**Proposed Variations to Planning Drawings**

Beachcombers, Cliffe Road, Kingsdown, CT14 8AJ  
 Variations to drawings relating to planning  
 permission 22/00962

**Drawing J1 - Front Elevation and Front part of  
 North Side Elevation**

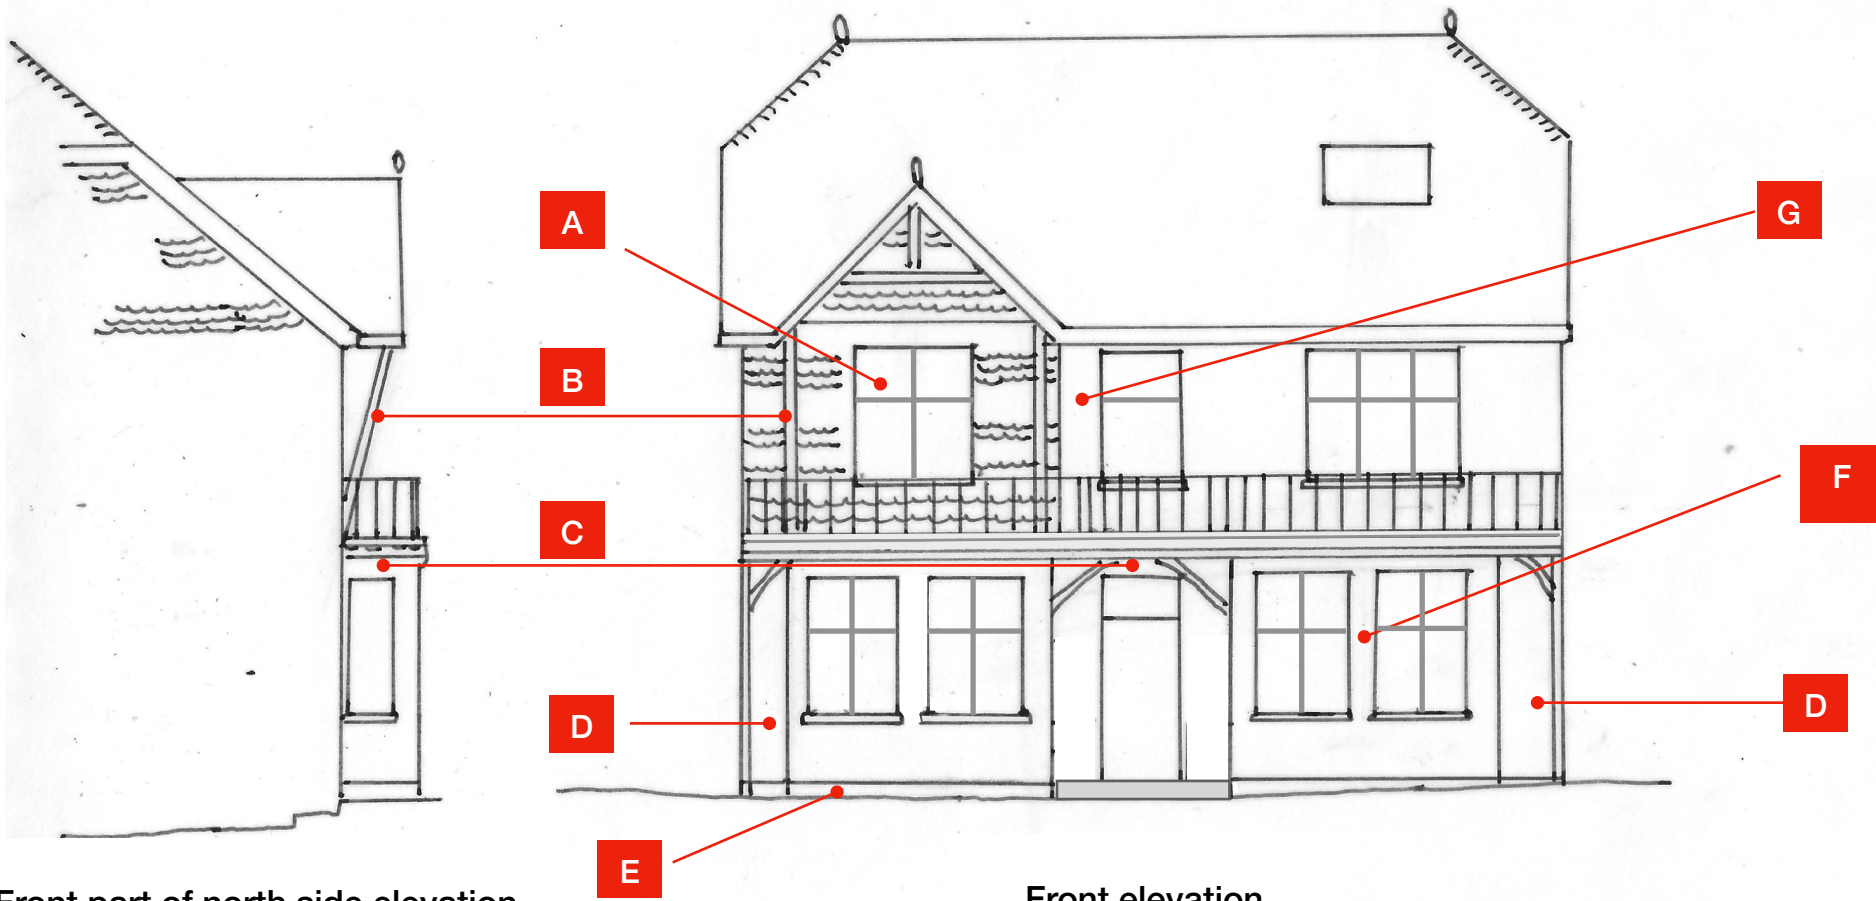
<b>A</b>	Slightly smaller window
<b>B</b>	Gable support changed
<b>C</b>	Porch becomes smaller, in line with bays
<b>D</b>	Brickwork to side of bays retained (no longer being tile hung)
<b>E</b>	Rendered and painted decorative skirt across front
<b>F</b>	Brick pillar in middle of both front bays for aesthetics and ease of construction and glazing
<b>G</b>	Reduced area of tile hanging, existing render retained
